**URGENT BUSINESS AND SUPPLEMENTARY INFORMATION****Planning Committee****6 November 2025**

**Joint Response of
Cherwell District Council
and
Oxfordshire County Council
to the Oxfordshire Strategic Rail Freight Interchange Stage 2
Consultation**

November 2025

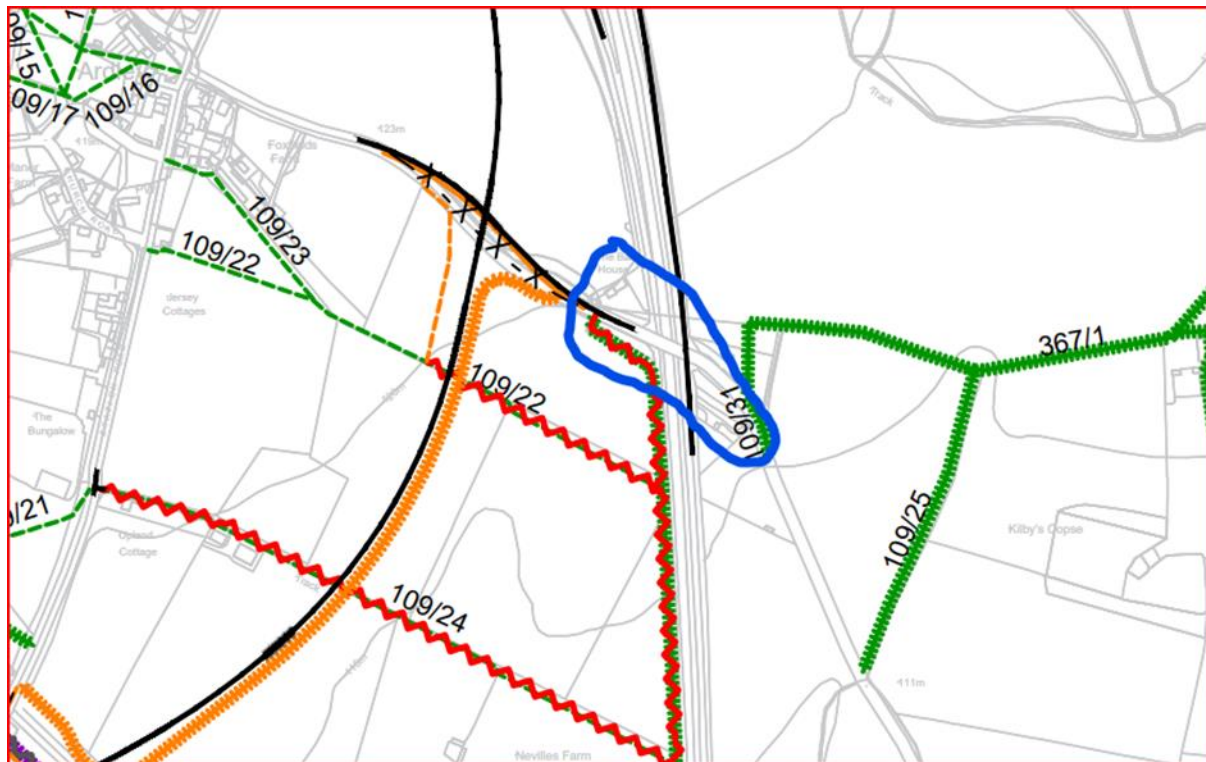
8.2.26 Cycle and pedestrian access is shown in the Walking, Cycling and Rights of Way Strategy Plan and provides an off-carriageway link to Ardley as part of the main access junction/Ardley bypass works. An off-carriageway cycle link would connect the site at its southern end to works to be provided by the current permissions at Heyford Park in Phase 1, and a cycle route along the site frontage on the B430 would be provided.

- 8.2.27 The Sustainable Transport Strategy acknowledges the importance of providing a cycling route to Bicester, and this is a requirement that OCC strongly supports. In phase 1 this is proposed to be part-provided via the Greenway bridleway upgrade via Trow Pools Nature Reserve to Aldershot Farm at NW Bicester, which is to be funded from current planning permissions at Heyford Park, as well as funding from development at NW Bicester. This will eventually provide a route away from motor traffic, suitable for use by all types of bicycle, horse and pedestrians but would be unsealed, narrow, unlit and isolated, and therefore unattractive for many users as a commuting/utility route and not compliant with LTN 1/20 standards, albeit it would be used by some commuters in preference to cycling along roads, and for leisure purposes.

- 8.2.28 In Phase 2, it is proposed that an off carriageway cycle link would connect the southern access alongside the new Heyford Park Link Road and Middleton Stoney Relief Road to a new cycleway connection linking with the minor road between Middleton Stoney and Bucknell, where cyclists could cycle on-carriageway (with traffic calming) into the future network of the proposed Hawkwell Farm cycle routes, or the eastern portion of the above mentioned bridleway. The Sustainable Transport Strategy describes how this option (Route 3) was selected over a route (Route 4) that continued alongside Middleton Stoney Road to connect with existing and proposed facilities at the forthcoming Himley Village development. The main reason was constraints of available highway width along Middleton Stoney Road.
